City of Sydney submission on the Draft Central Western Gateway Block Rezoning Proposal

RE: Proposed amendments to the planning controls for Block C (Adina Hotel) within the Western Gateway sub precinct

Actual view of the Parcels Post Building (left) and the actual impact on the building indicating that the entire southern elevation will essentially be obscured (Source: Google Maps with National Trust overlay (left) and Visual Assessment Report, Urbis, November 2020, p.24 (right))

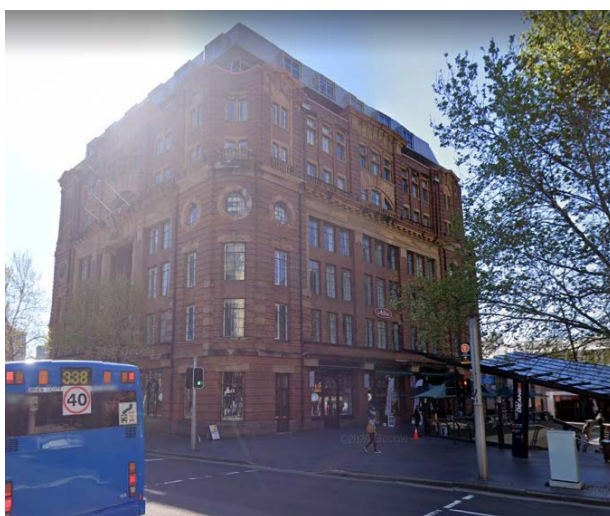
The above illustration shows the building already obscured by trees. A more useful view assessment would be from Railway Square itself, or from the Devonshire Street tunnel entry. The actual visual impact that the proposal will have can be garnered from the contrasting images below. Such studies should form part of this assessment, not specifically selected views of the building already obscured by trees and other structures.
